Improved TDEC and SEC limit for 100GBASE-SR4

Piers Dawe

IEEE P802.3bm, November 2014, San Antonio

Simulated eye with TDP approaching 5 dB

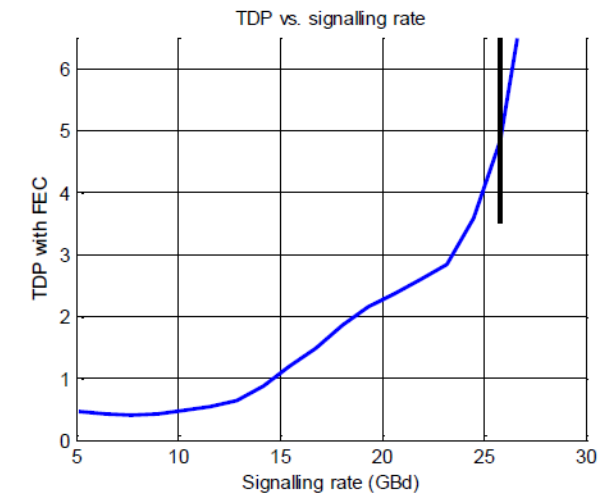
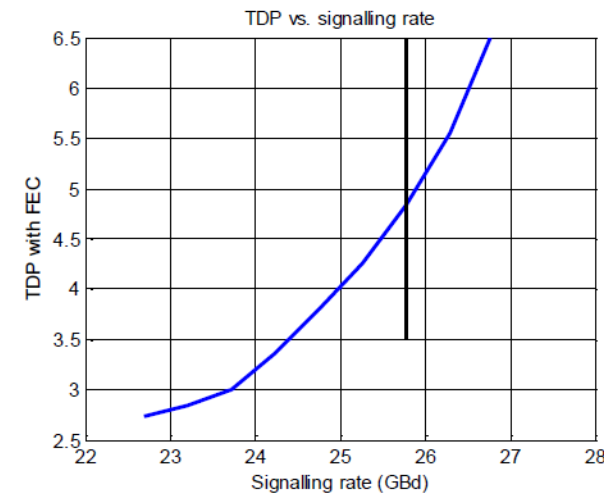
- TDP like Clause 52: +/-0.05 UI, but:
 - BER = 5e-5
 - 100 m of OM4 modelled as a Gaussian filter, like spreadsheet model
 - Standard fourth-order Bessel-Thomson
- Includes ISI from chromatic dispersion but not MPN
- Is this on the cliff edge?

- Slide 12 of dawe_02a_0114_optx, slides 4, 5 of dawe_01_0513_optx
- This eye is on the "**cliff edge**": about to collapse
- Since this work, widening the decision timing offsets and changing to TDEC has helped
- TDEC limit should be reduced from 4.9 dB
- See dawe_01_0914_optx

TDP vs. signalling rate

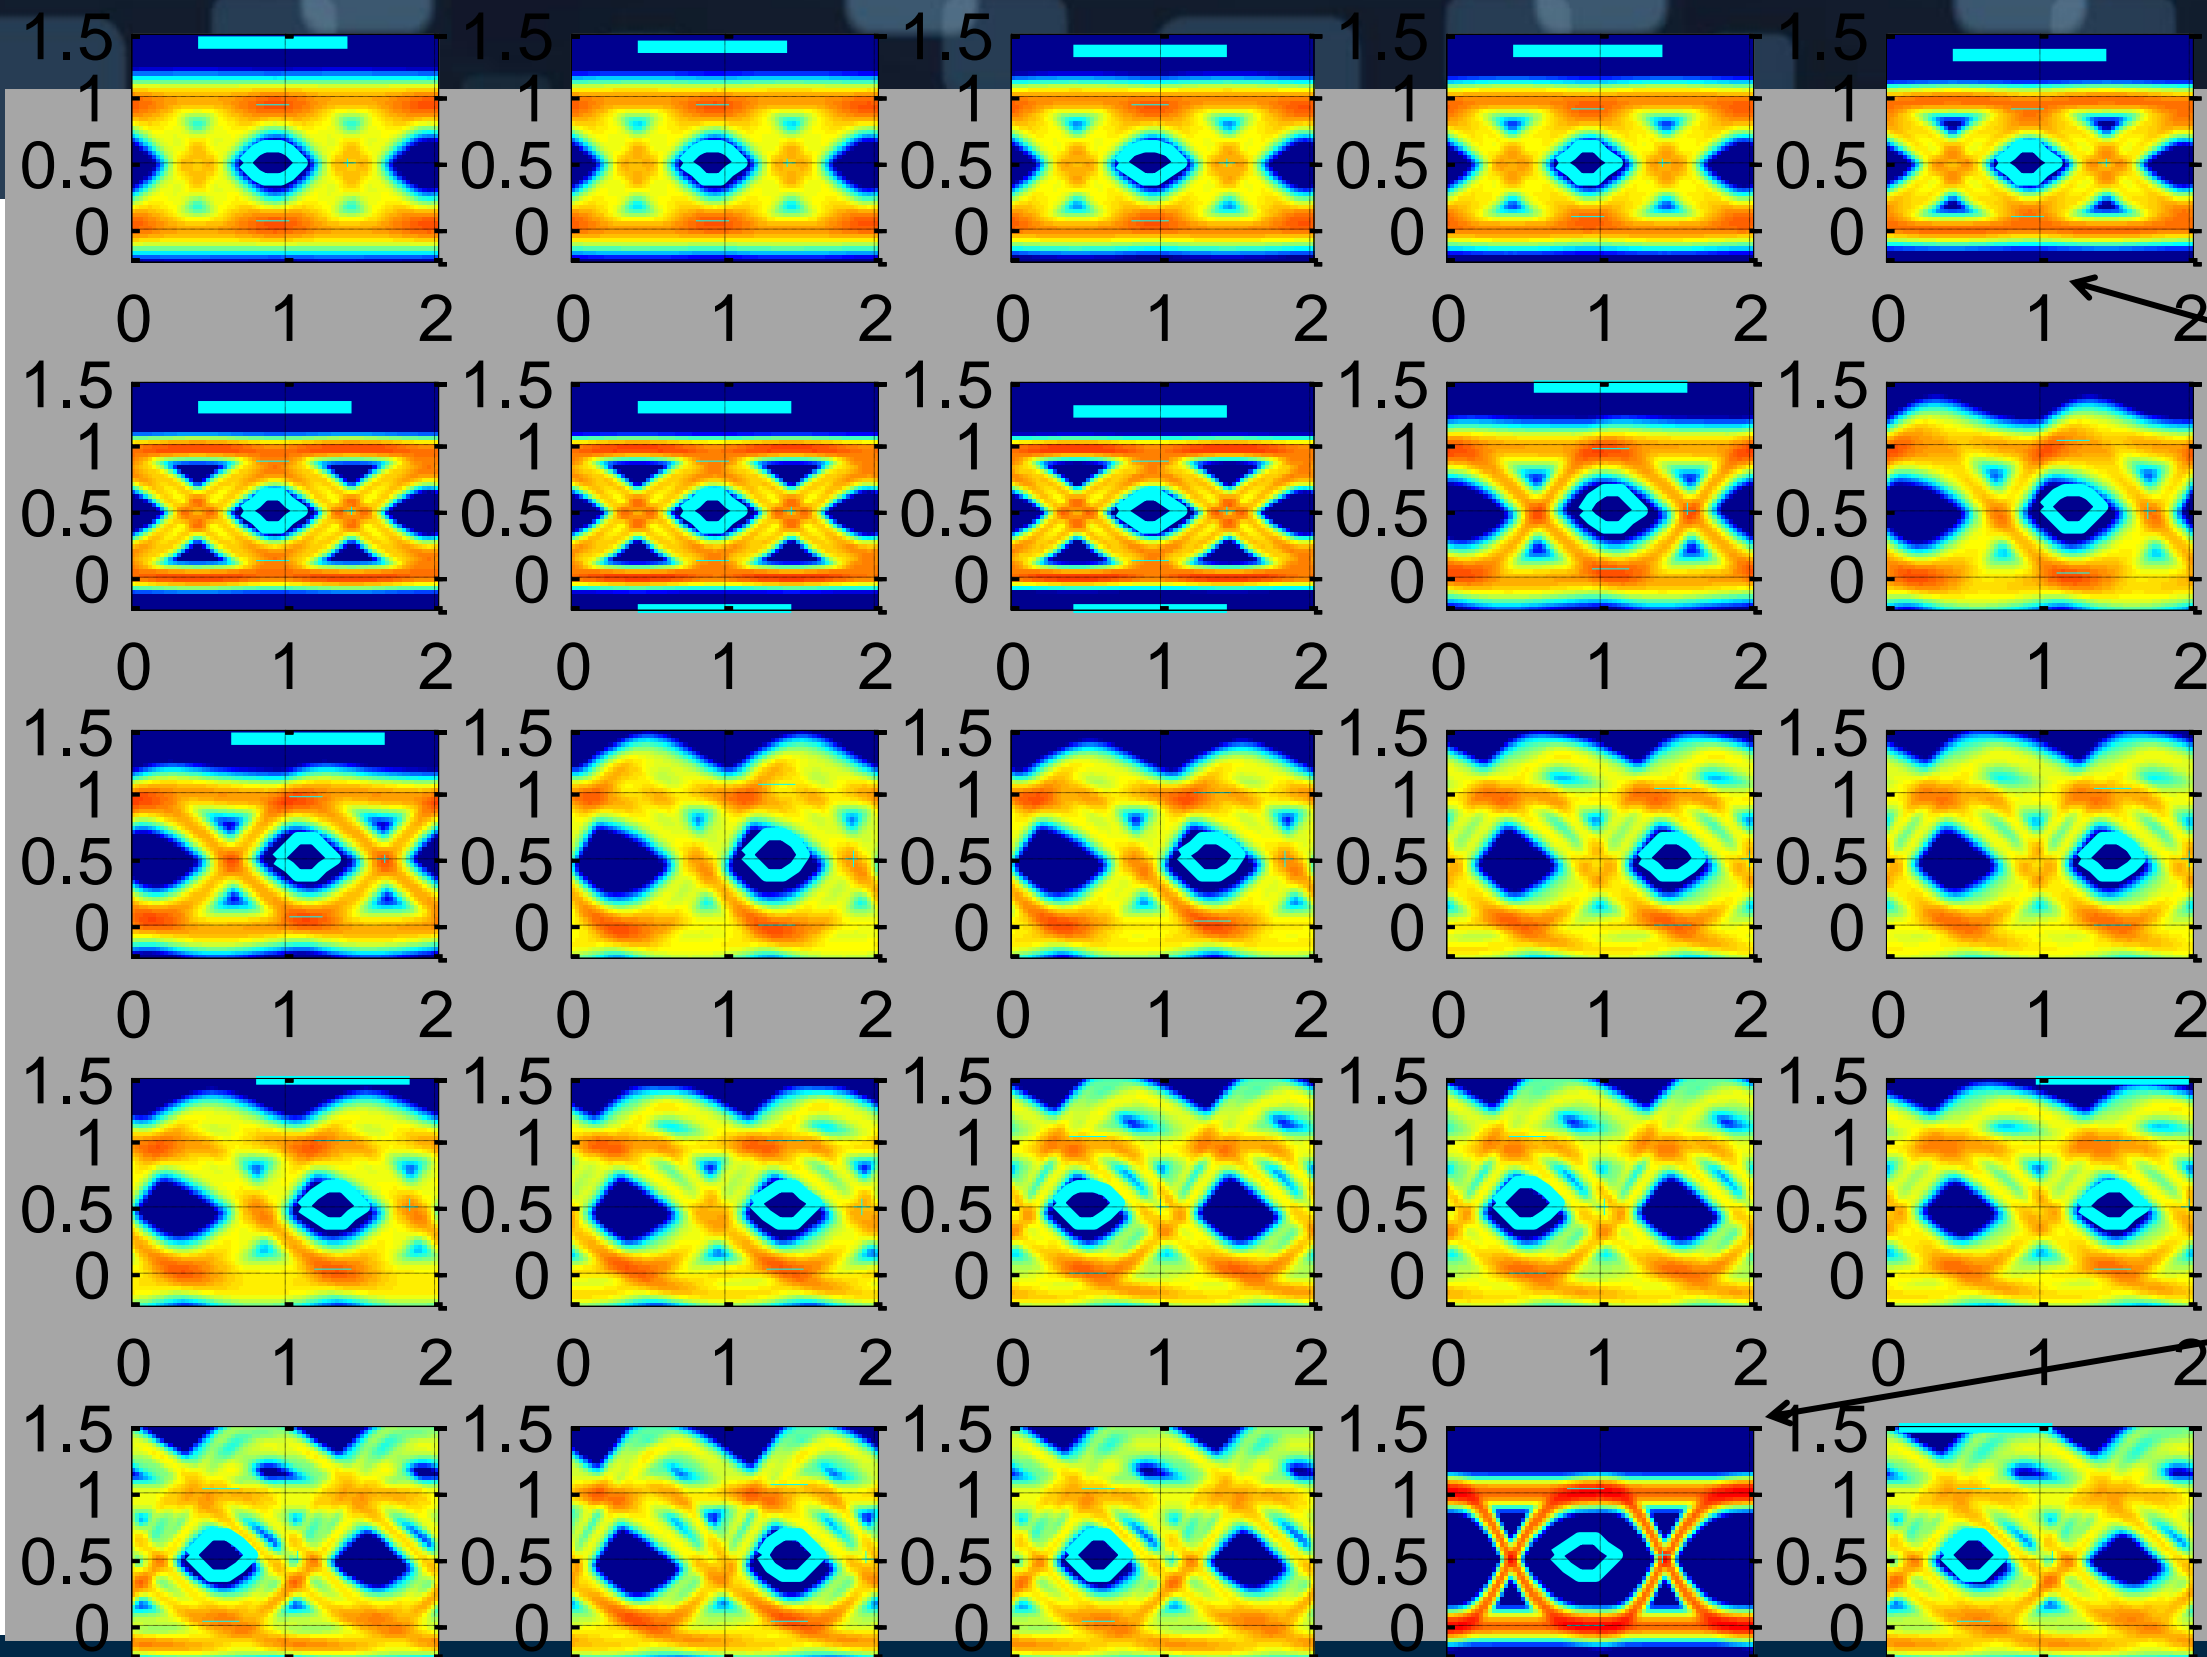
- IC bandwidths scaled with signalling rate, laser not scaled
- 2% rate change increases TDP by 0.7 dB – yes, cliff edge
